LHC ECR: LHC-Y-EC-0021

**LHC safety system modifications due to
HL-LHC during LS2**

HL-LHC TCC, 7 June 2018

ENGINEERING CHANGE REQUEST		
LHC Safety System Modifications Due To HL-LHC During LS2		
<p>BRIEF DESCRIPTION OF THE PROPOSED CHANGE(S):</p> <p>The new HL-LHC caverns will be connected to the LHC tunnel during LS2 via emergency exit galleries UPR. During the run 3 the UPR galleries need to be closed off from the HL-LHC galleries with end-of-zone doors supervised by the LASS. In addition, ODH detection, automatic fire detection, evacuation/BIW system, red telephones, RAMSES radiation monitoring, and Technical Network connectivity need to be installed.</p>		
<p>DOCUMENT PREPARED BY: T. Hakulinen BE-ICS</p>	<p>DOCUMENT TO BE CHECKED BY: C. Adoriso, M. Arnaud, G. Balasz, M. Barberan, I. Bejar Alonso, M. Bernardini, N. Broca, S. Bustamante, J.P. Corso, B. Dellile, B. Di Girolamo, S. Di Luca, P. Fessia, R. Folch, K. Foraz, C. Gaignant, G. Girardot, S. Grau, J.C. Guillaume, J.F. Juget, M. Lamont, F. Magnin, S. Maridor, A. Martinez Selles Y. Muttoni, P. Ninin, R. Nunes, T. Otto, D. Perrin, D. Raffourt, J. Ramos, S. Roesler, P. Sollander, R. Steerenberg, L. Tavian, M. Tavlet, LHC CS

ACCESS SYSTEM

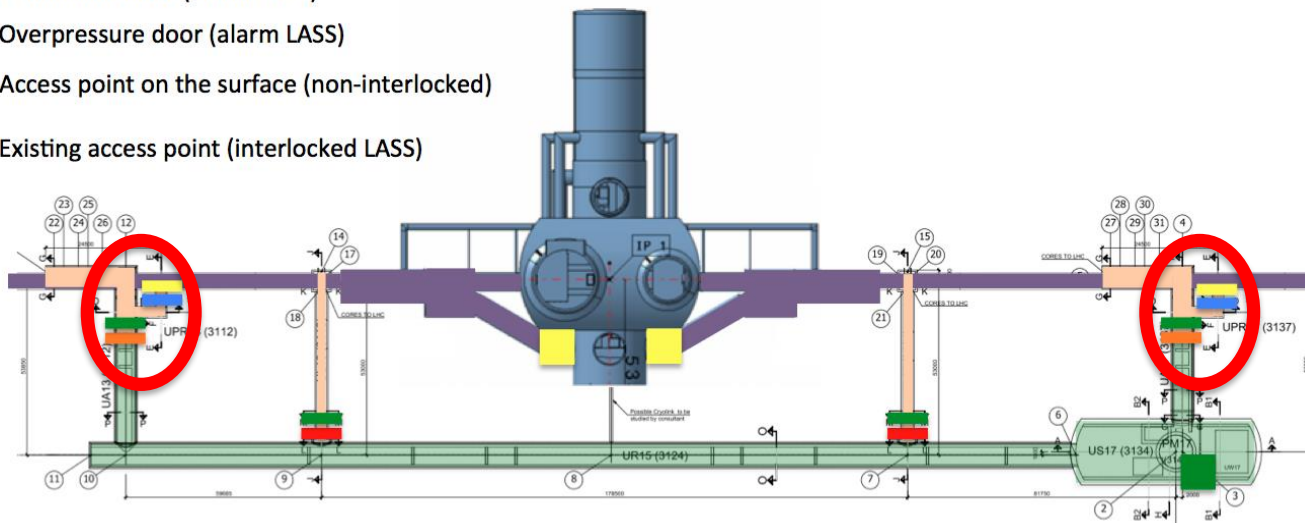
- 4 new sectors: UPR13, UPR17, UPR53, UPR57.
- 4 new end-of-zone doors
- 4 new sector doors
- 8 new ventilation doors
- 12 new patrol boxes
- 4 new racks

-  Grated end-of-zone door (interlocked LASS)
-  Solid end-of-zone/ventilation door (interlocked LASS)
-  Grated sector door (interlocked LASS)
-  Ventilation door (alarm LASS)
-  Overpressure door (alarm LASS)
-  Access point on the surface (non-interlocked)
-  Existing access point (interlocked LASS)

-  Inner triplet area (interlocked LASS)
-  Non-accessible HL-LHC galleries (interlocked LASS)
-  Accessible HL-LHC galleries (non-interlocked)

OXYGEN DEFICIENCY HAZARD (ODH) DETECTION

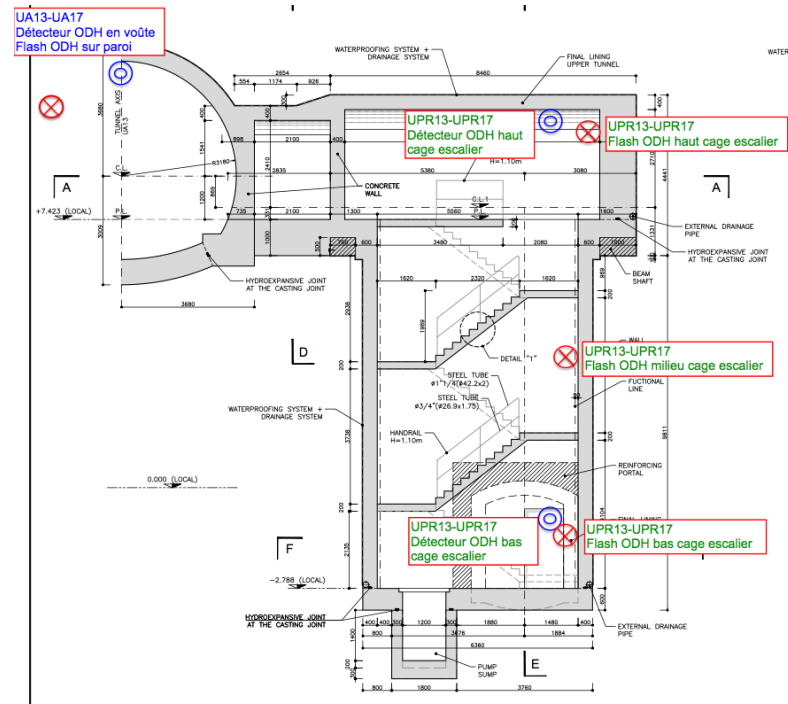
- 1 ODH detector in UA13, UA17, UA53, UA57.
- 2 ODH detectors in UPR13, UPR17, UPR53, UPR57.
- 1 ODH flash signal in UA13, UA17, UA53, UA57.
- 3 ODH flash signals (one at top, one at middle, one at bottom) in UPR13, UPR17, UPR53, UPR57.
- Cabling for each individual ODH detector from service areas of Point 1 and Point 5.

AUTOMATIC FIRE DETECTION (AFD)

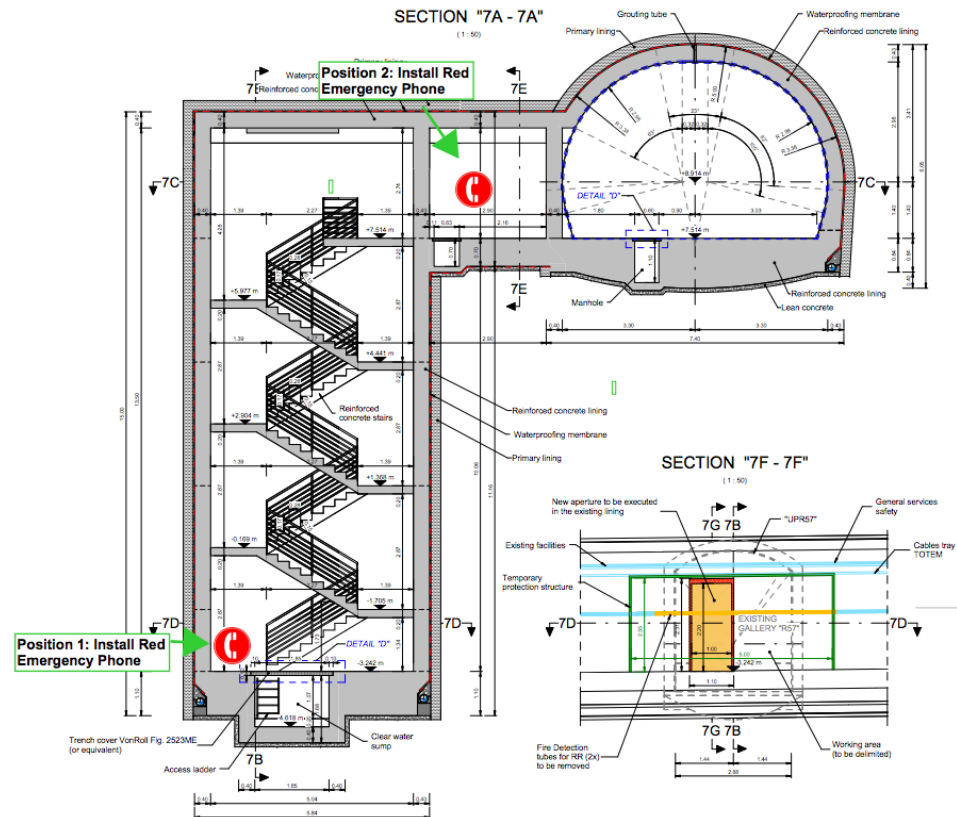
- 2 fire detection tubes to UA13/UPR13 from sampling units in service areas of P1.
- 2 fire detection tubes to UA17/UPR17 from sampling units in service areas of P1.
- 2 fire detection tubes to UA53/UPR53 from sampling units in service areas of P5.
- 2 fire detection tubes to UA57/UPR57 from sampling units in service areas of P5.
- 2 new sampling units in service areas of P1 and P5 (1 unit / 2 tubes).
- 4 point-detectors, one in each UA overpressure sas. Cabling is to be pulled from the service areas.

Waiting for confirmation from RP that radiation levels at the UPRs are compatible with placing sampling units there → installation / cost optimization possible.

RADIATION MONITORING

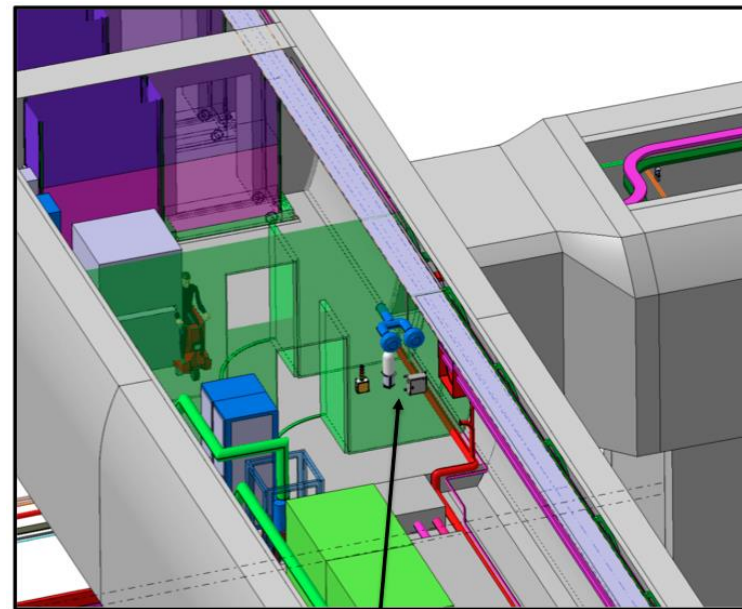
- 1 “Crome” radiation monitor and 1 signalling flash light outside of the interlocked zone of each UA gallery (UA13, UA17, UA53, UA57).
- 1 extra signalling flash outside the protective wooden wall in the UA during the CE works.
- 1 uninterruptible power unit on the interlocked side of each UA gallery.

FIREFIGHTING EQUIPMENT

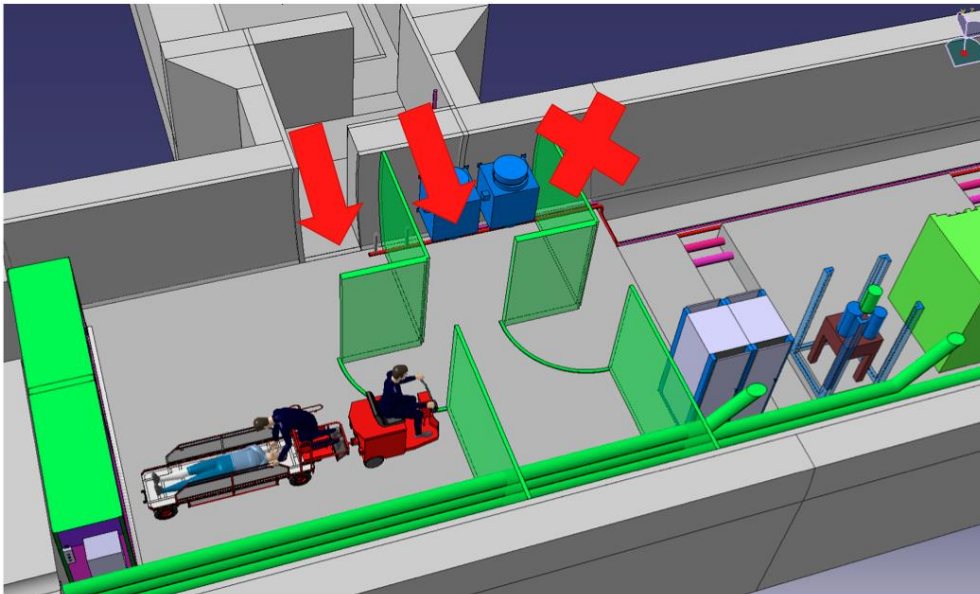
- In the final configuration after LS3 there will be RIA/STORZ installed for fighting fire. However, after LS2 these equipment will not yet be available.
- The Fire Brigade will position an electrical 2-seat tractor and a fire intervention trailer equipped with a CAFS (Compressed Air Foam System), spare SCBA (Self-Contained Breathing Apparatus), hose loads, forcible entry tools and extinguishers into the interlocked part of the UA.

NETWORKING

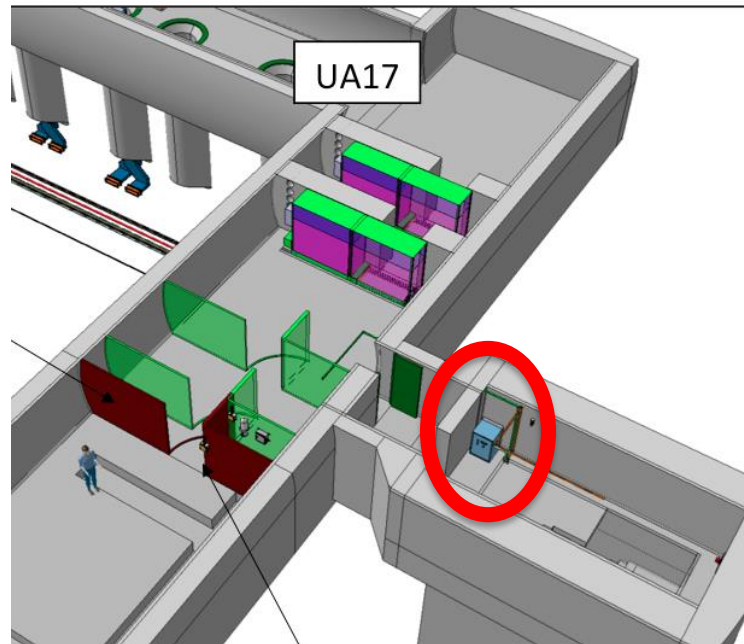
- IT starpoint rack on the top level of each UPR.
- Fiber-optic cabling from the closest IT starpoint in the service areas of P1 and P5.
- Network sockets and local cabling from the starpoint rack to each socket: 6 sockets in each UA, 2 sockets at the top of each UPR and 4 sockets at the bottom of each UPR.
- Radiation monitoring and CV equipment connected to TN.
